# CITY of NOVI CITY COUNCIL

## Agenda Item 2 April 1, 2019

**SUBJECT:** Approval of the request of Ramco West Oaks II LLC for JSP 18-33 Starbucks Expansion with a Drive-Through for a Special Land Use, a Preliminary Site Plan with a PD-2, Planned Development Option, and a Storm Water Management Plan. The subject property is located on the west side of Novi Road, south of Twelve Mile Road in West Oaks Shopping Center in Section 15. The applicant is proposing an expansion of the existing Starbucks coffee shop with an addition of a drive-through facility.

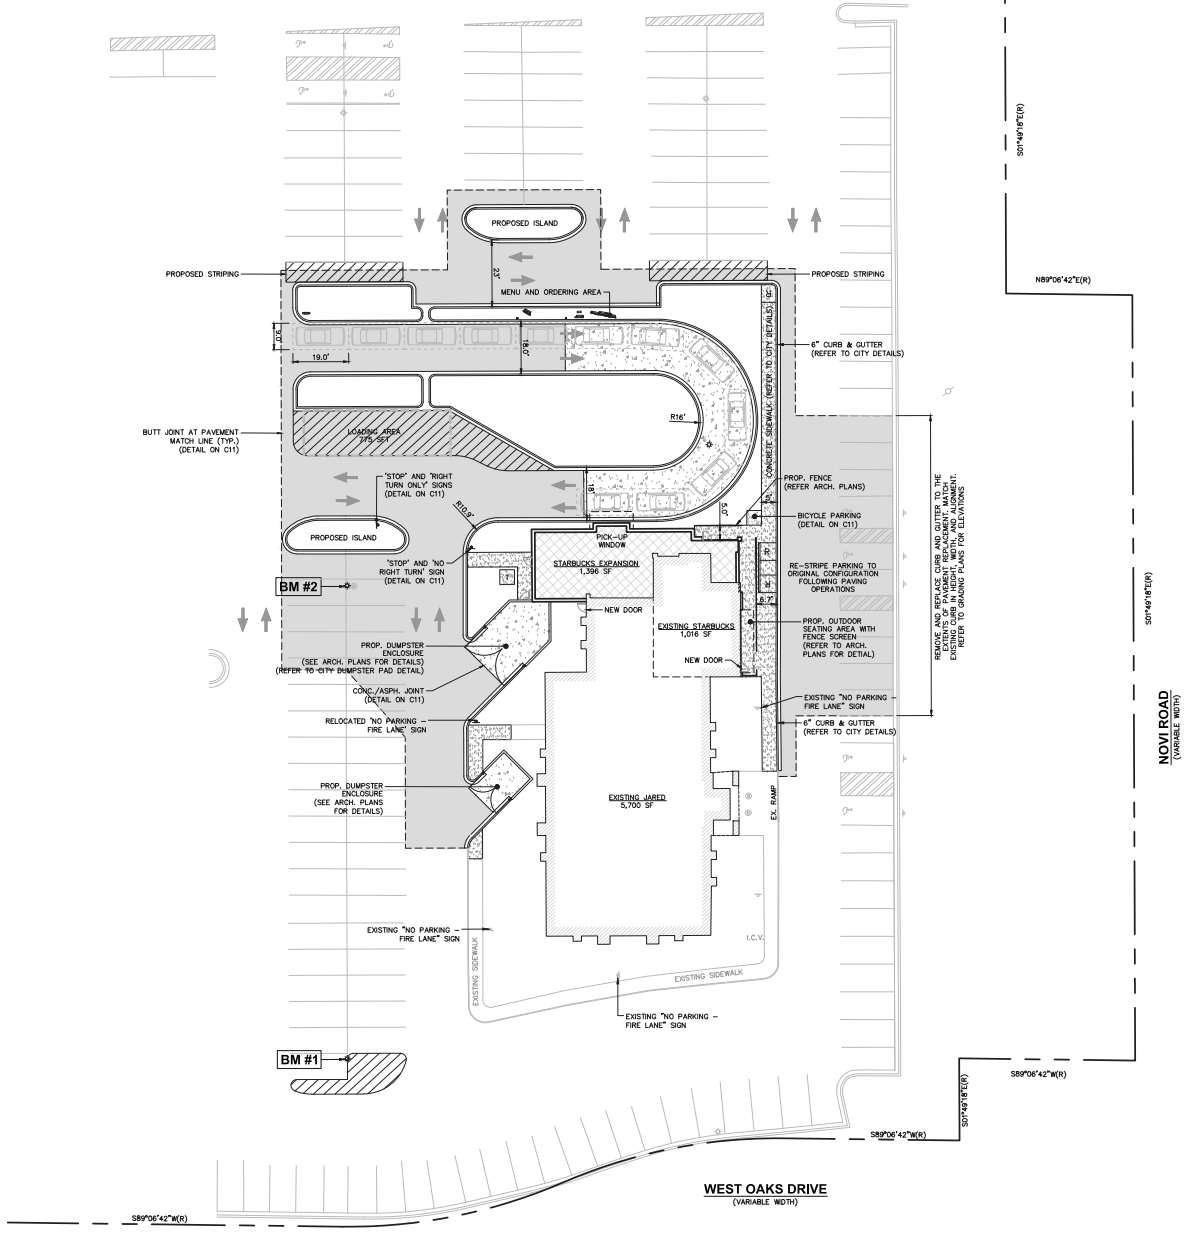
- i. The applicant has indicated that the drive-thru lane and bypass lane each have an effective width of nine feet.
  - ii. The applicant should indicate the centerline radius of the drive-thru lane. City Zoning Ordinance requires a 25 foot centerline radius (Section 5.11.F) **25' radius dimension provided on sheet C04.**

The drive-thru layout has been modified to allow for a larger turning area as suggested. Refer to sheet C04.

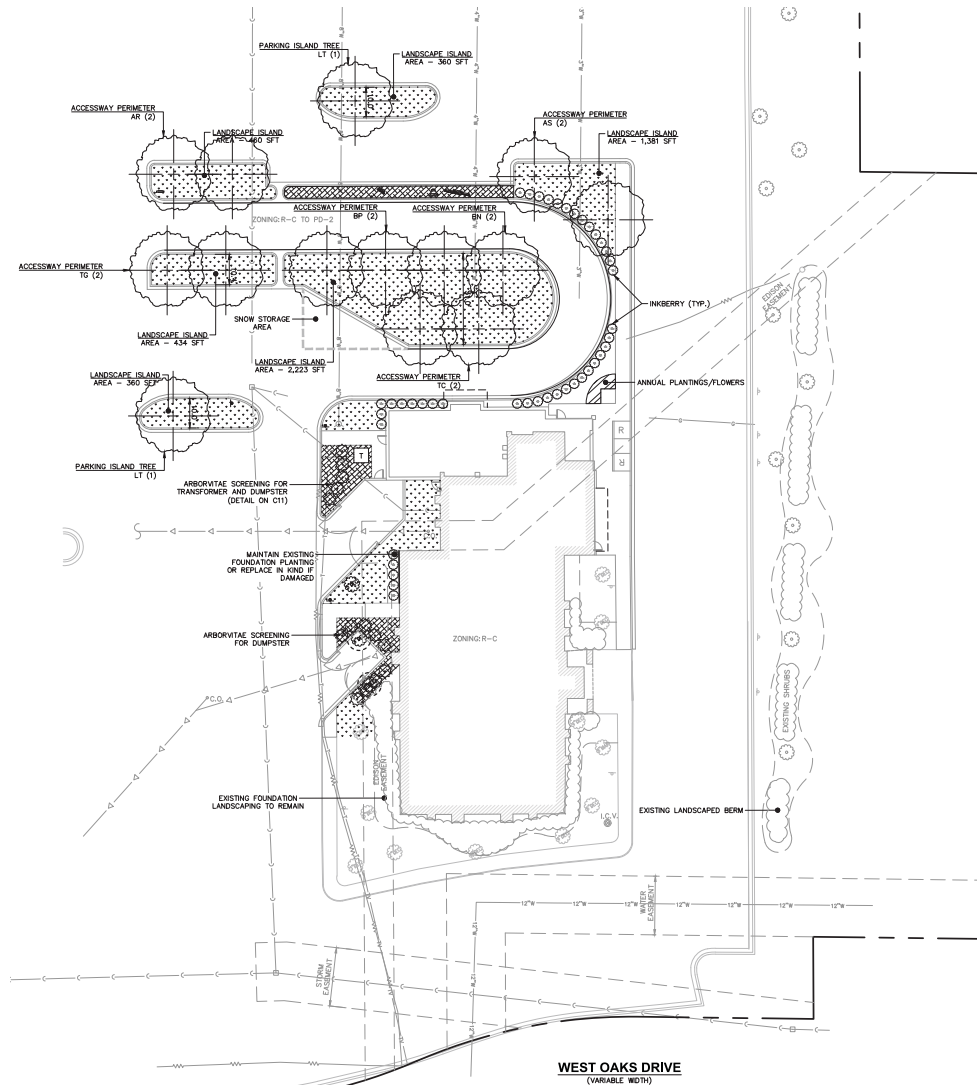
Item	Required	Proposed	Meets Code	Comments
(LDM 2.e.(1))		on Sheet C05		
<b>Snow deposit</b> (LDM.2.g.)	Show snow deposit areas on plan	Yes	Yes	
<b>LANDSCAPING REQUIREMENTS</b>				
<b>Parking Area Landscape Requirements LDM 1.c. &amp; Calculations (LDM 2.o.)</b>				
<b>General requirements</b> (LDM 1.c)	<ul style="list-style-type: none"> <li>Clear sight distance within parking islands</li> <li>No evergreen trees</li> </ul>	Yes	Yes	
<b>Name, type and number of ground cover</b> (LDM 1.c.(5))	As proposed on planting islands	Yes	Yes	Please provide a legend for all hatching or use callouts to make clear what the ground treatments are.
<b>Callouts and hatching have been provided on the landscape plan indicating all ground treatments.</b>				
<b>General (Zoning Sec 5.5.3.C.ii)</b>				
<b>Parking lot Islands</b> (a, b, i)	<ul style="list-style-type: none"> <li>A minimum of 200 SF to qualify</li> <li>A minimum of 200sf unpaved area per tree planted in an island</li> <li>6" curbs</li> <li>Islands minimum width 10' BOC to BOC</li> </ul>	Yes	TBD	Please dimension widths of islands in linear feet.

<b>Island widths provided. Refer to sheet C09.</b>				
<b>Curbs and Parking stall reduction</b> (c)	Parking stall can be reduced to 17' and the curb to 4" adjacent to a sidewalk of minimum 7 ft.	Endcap islands are provided north and south of drive-thru.	TBD	It appears that the parking bay east of the new northern island will be needed to be provided with endcap island too.
<b>Contiguous space limit</b> (i)	Maximum of 15 contiguous spaces	Parking bays are not enlarged by the project.	Yes	See above.
<b>Plantings around Fire Hydrant</b> (d)	No plantings with matured height greater than 12' within 10 ft. of fire hydrants	All trees are 10 feet from hydrants.	TBD	<ol style="list-style-type: none"> <li>Trees should also be 5 feet from underground lines.</li> <li>Please show all utilities on landscape plan and adjust lines/trees to avoid conflicts.</li> </ol>
<b>Utility information has been provided on sheet C09.</b>

DRAWN BY: EM/JC  
CHECKED BY: EM  
PROJECT MANAGER: MMC  
JOB #: 17022665  
FILE CODE: 0P  
SHEET NO.: C11

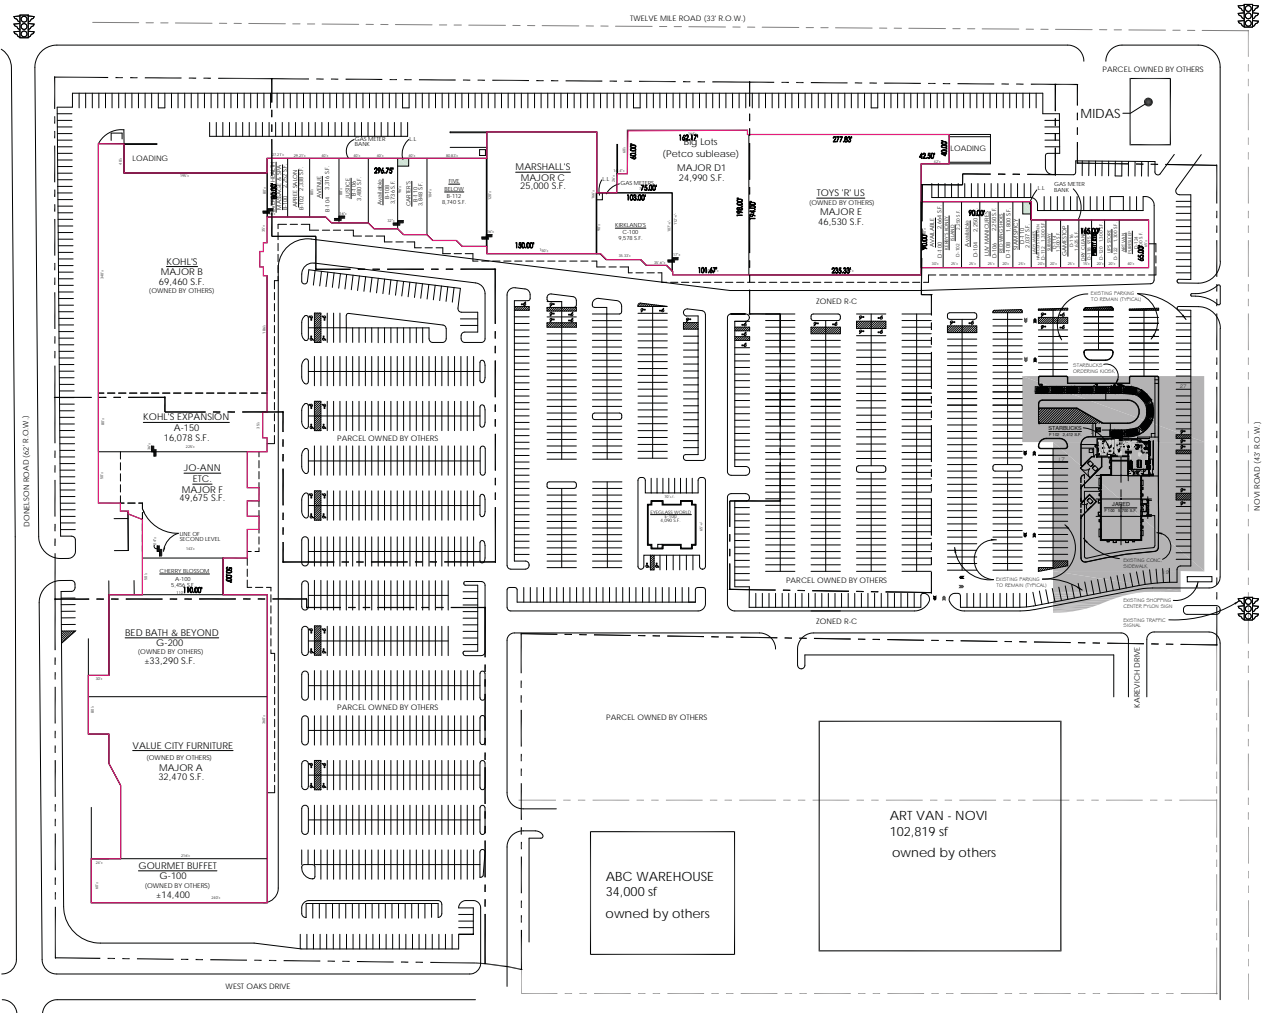
19. Refer to city standard paving detail sheets for minimum pavement cross sections and mix types. Revise details on sheet C11 to be consistent with these standards and remove any redundant or conflicting details.

Paving details on sheet C11 have been revised to meet the City's minimum pavement cross sections and redundant/conflicting details have been removed. The revised C11 will be provided with the FSP.
